BMC MINERALS (NO.1) LTD

KUDZ ZE KAYAH PROJECT

RESPONSE TO YESAB EXECUTIVE COMMITTEE ADEQUACY REVIEW OF KZK

July 2017

**FIGURE 13-5
2015, 2016 AND 2017
MOOSE SIGHTINGS**

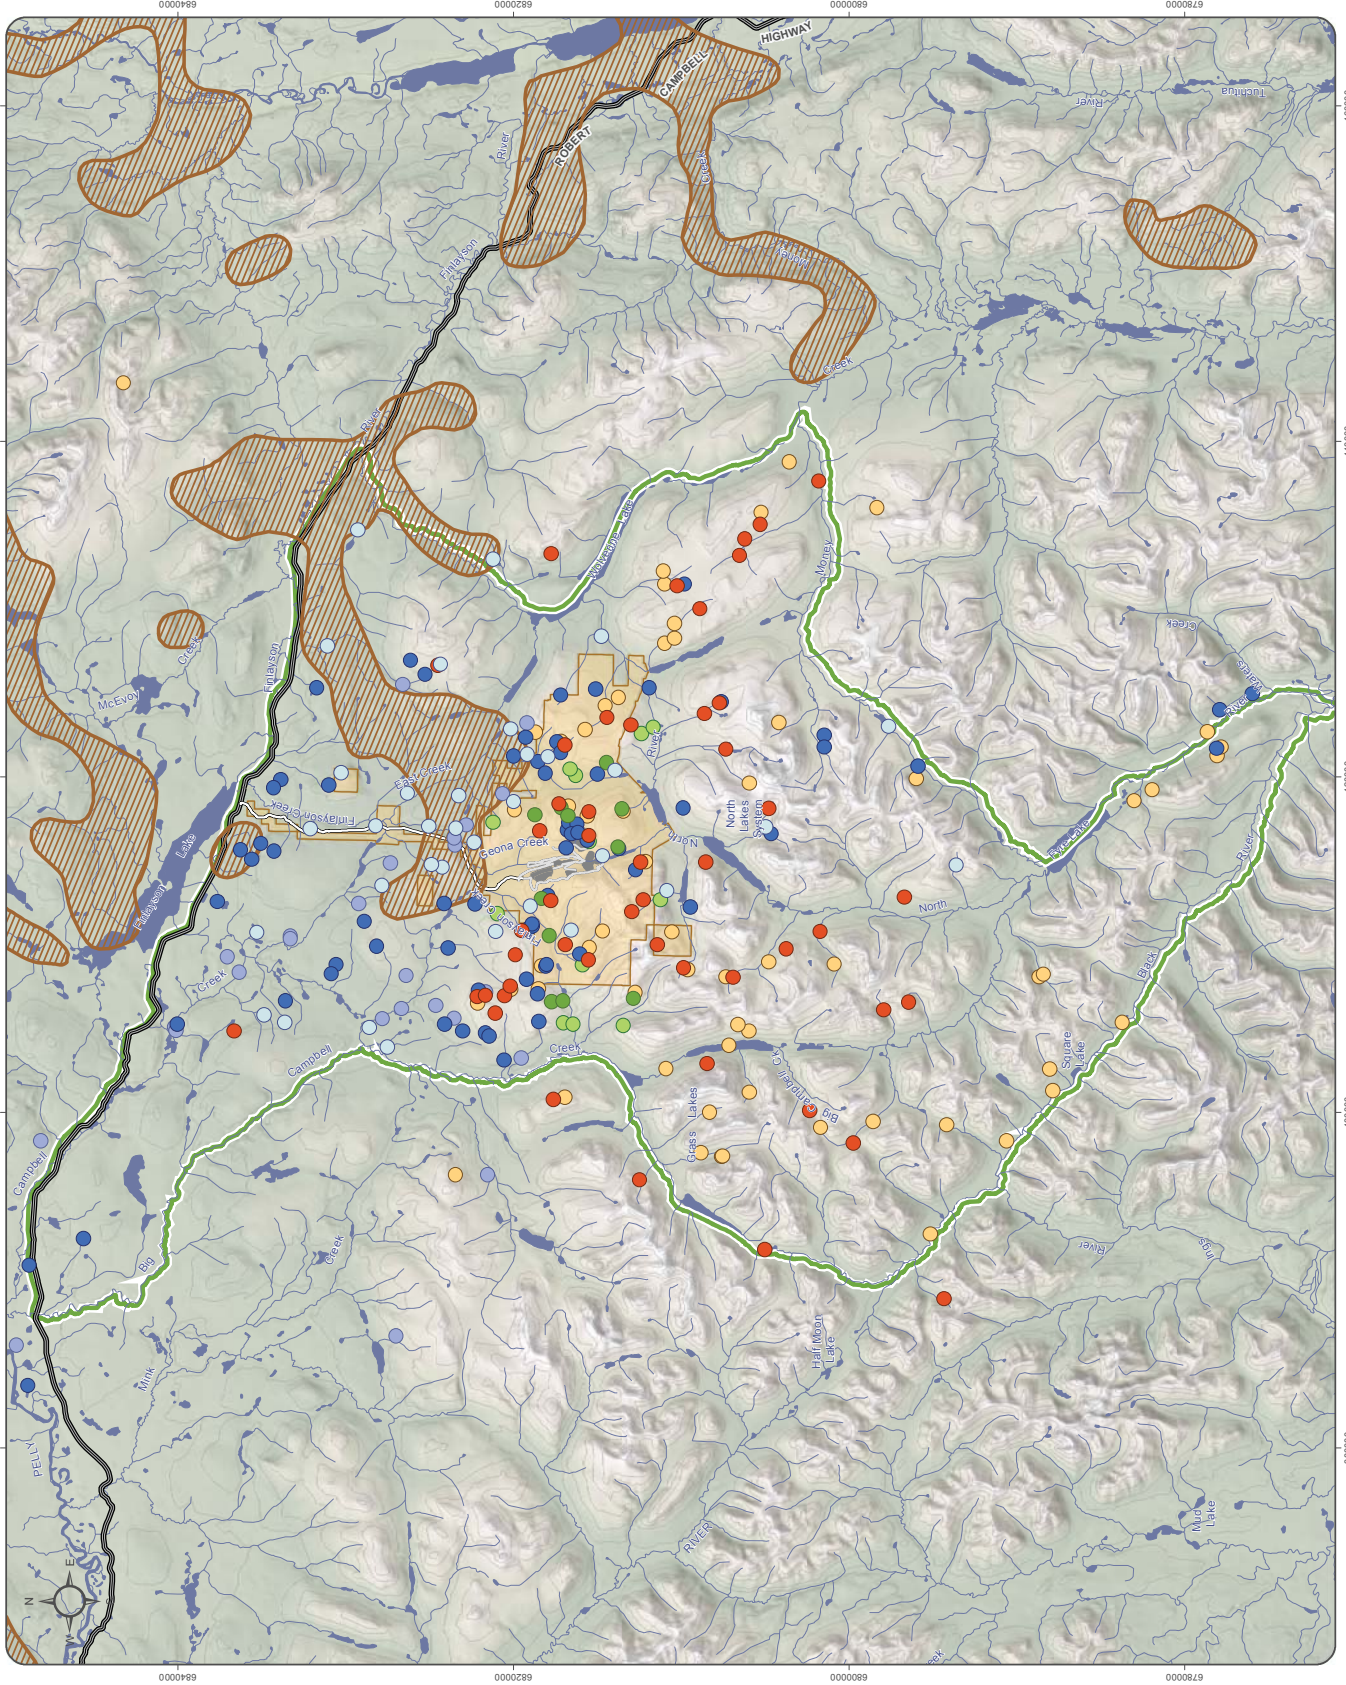
“Revise Figure 4-1 to make seasonal patterns of moose distribution clear.”

Figure 4-1 has been revised and included with these responses as Figure 13-5 (above) and includes observations from the December 5-6, 2016 post-rut survey and March 23-24, 2017 late-winter survey. From the observations, moose are distributed throughout the mountain valleys in fall and generally move to Pelly and Finlayson lowlands in the winter.

**FIGURE 20-1
ACCESS ROAD ALIGNMENT AND
POTENTIAL BORROW SOURCES**

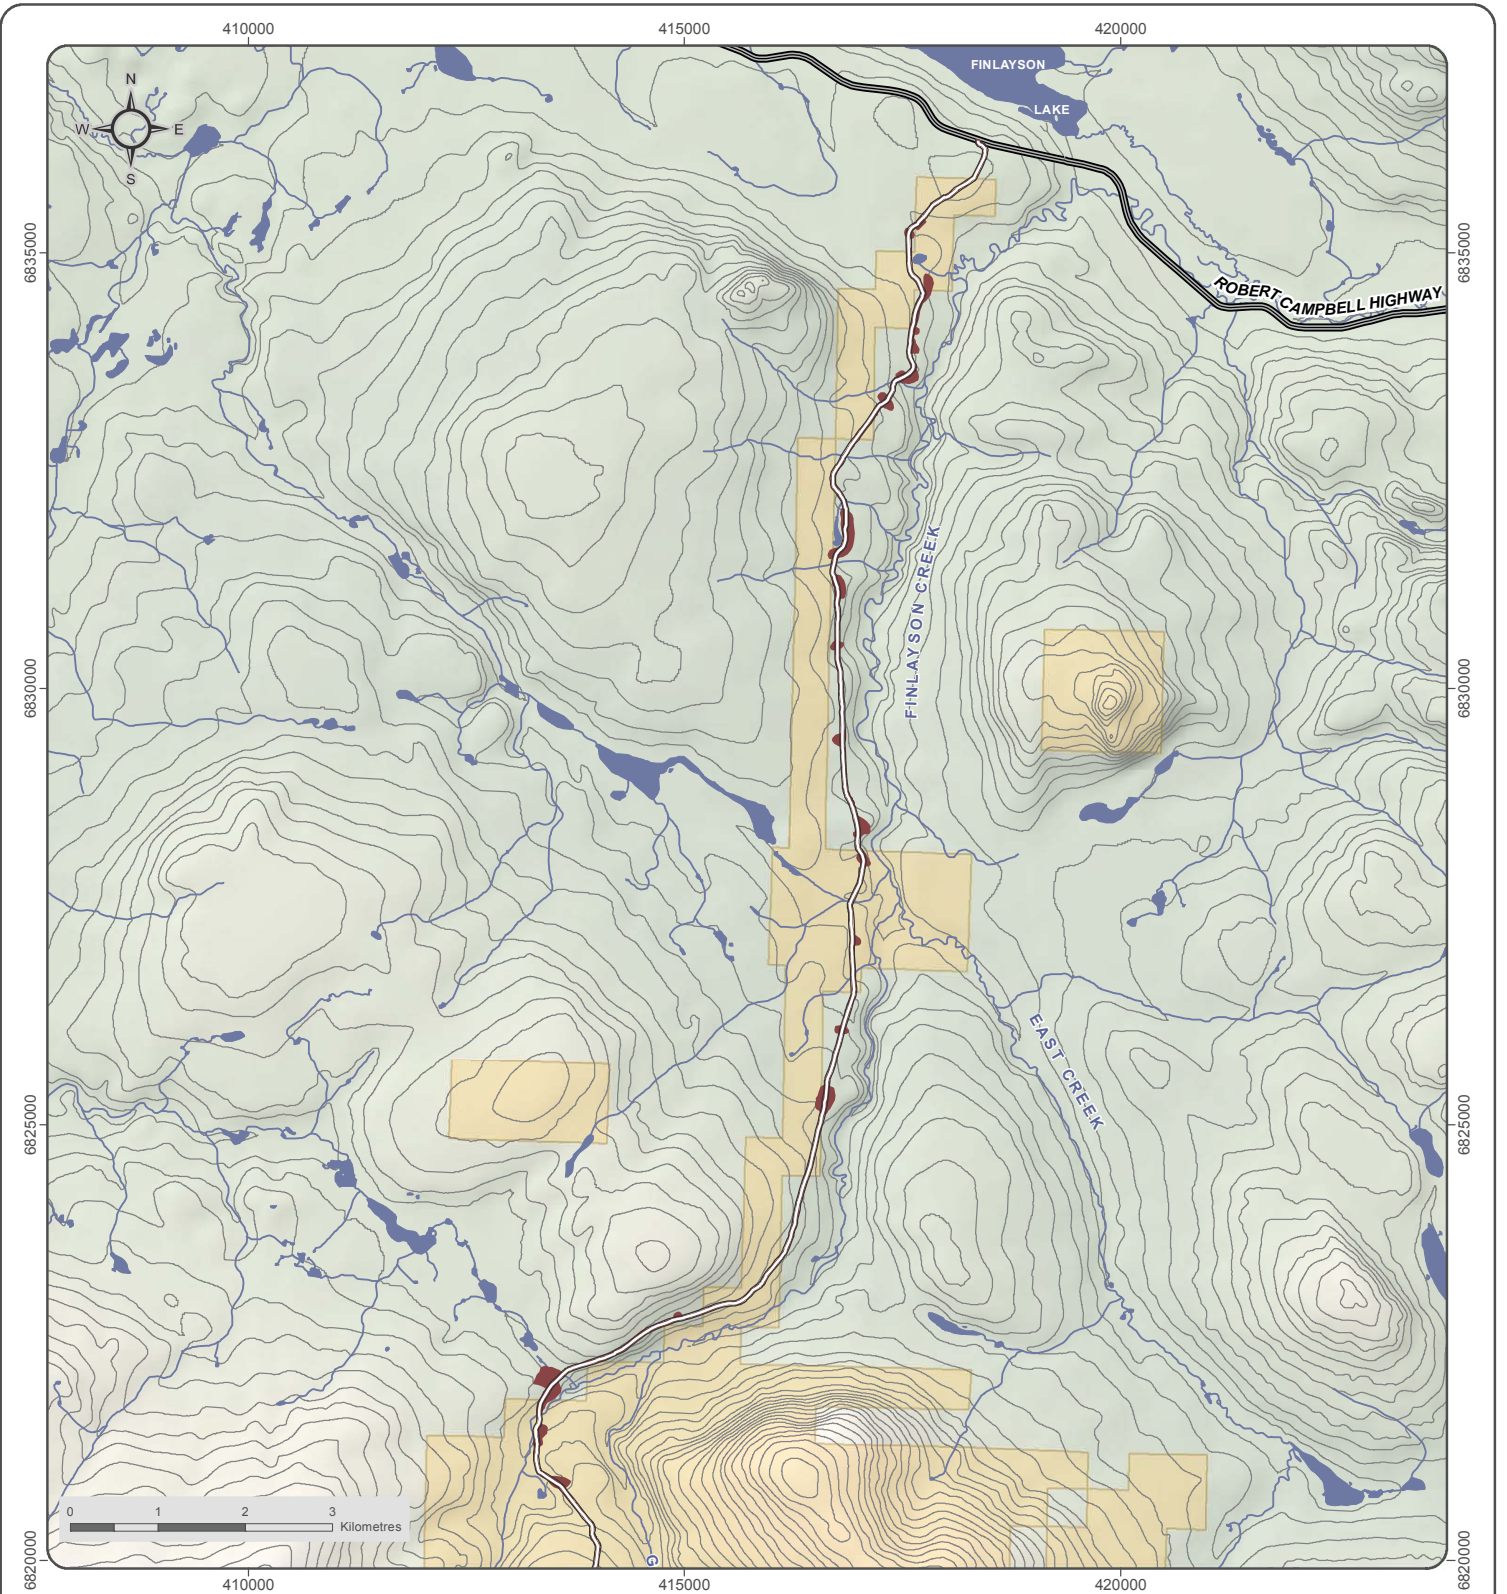
In the Project Description (pages 4-106 and 4-107), borrow sources information is lacking. The current land lease does not speak to borrow sources and no other authorization from LMB has been granted for Borrow Sources. LMB considers Borrow Sources to be a quarry; as a result, a quarry lease and permits would need to be applied for.

Multiple borrow sources have been identified and sampled in the field, with the locations of all potential borrow sources for the access road illustrated in Figure 4-19 of the Project Proposal (reproduced as Figure 20-1, below). These locations were largely those that had previously been identified and utilised as borrow sources for the construction of the Tote Road in 1995. While all potential borrow sources have been identified on this Figure, only some of them will be required for construction purposes, and the selection of specific borrow sources for construction is intended to be determined by the construction contractor during detailed planning of construction activities.
